LR-N05-0397
LCR S05-07

**REQUEST FOR CHANGE TO TECHNICAL SPECIFICATIONS TO REVISE
STEAM GENERATOR TUBE SURVEILLANCE REQUIREMENTS IN
ACCORDANCE WITH WCAP-14797, REVISION 2 (W* METHODOLOGY)
SALEM GENERATING STATION - UNIT 2
DOCKET NO. 50-311
FACILITY OPERATING LICENSE NO. DPR-75**

**CHANGE TO TECHNICAL SPECIFICATIONS TO REVISE STEAM GENERATOR
TUBE SURVEILLANCE REQUIREMENTS IN ACCORDANCE WITH WCAP-14797,
REVISION 2 (W* METHODOLOGY)**

Sketch of W* Distance in Salem Unit 2 Steam Generator Tube Sheet

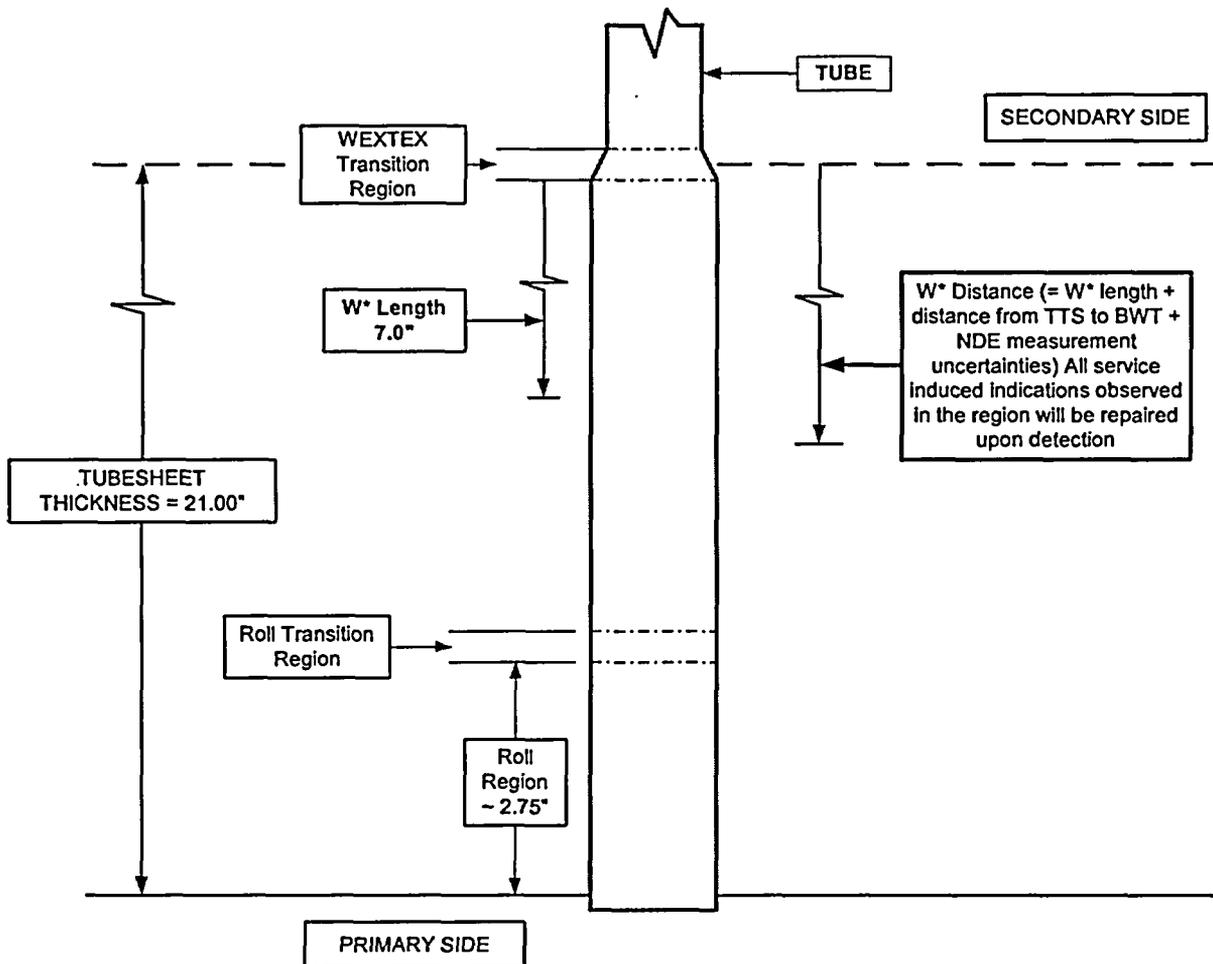
For the Salem Unit 2 Westinghouse Model 51 Series SGs with WEXTEx expansions, the full depth tube-to-tubesheet expansion can be defined as follows: from the lower tube end and extending upward for a length of approximately 2.75 inches is a region expanded by a tube rolling expansion process, from the top of the rolled expansion region to the vicinity of the TTS the expansion joint was produced by the WEXTEx process. The resulting full depth tube-to-tubesheet expansion can be considered as four distinct areas. These are described in WCAP-14797 Revision 2 and depicted in the sketch on the following page as:

1. The Roll Region – The tube region that has been expanded by the tube rolling process. This region extends from the bottom of the tube to approximately 2.75 inches above the bottom of the tube.
2. The Roll Transition – The tube region that extends from the roll expanded region to the initially unexpanded region, which is subsequently expanded by the WEXTEx process.
3. The WEXTEx Region – The tube region explosively expanded to be in contact with the tubesheet. This region starts at the roll transition and extends to the WEXTEx transition in the vicinity of the tubesheet top.
4. The WEXTEx Transition – The tube region that acts as a juncture between the WEXTEx region and the unexpanded tube region. The region starts at the top of the explosively expanded region and extends for approximately 0.25 inches.

BWT – The bottom of the WEXTEX Transition is defined in WCAP-14797, Rev. 2, as approximately 0.25 inches from the top of the tubesheet.

W* length – The maximum length of tubing below the bottom of the WEXTEX transition (BWT) which must be demonstrated to be non-degraded and is defined in WCAP-14797, Rev. 2, Section 4.0 as 7.0 inches below the bottom of the WEXTEX transition on the hot leg side.

W* distance – The distance from the top of the tubesheet to the bottom of the W* length including the distance from the top of the tubesheet to the BWT and measurement uncertainties.

1. All service-induced indications within the W^* distance must be removed from service by tube plugging.
2. Any type or combination of tube degradation below the W^* distance is acceptable.
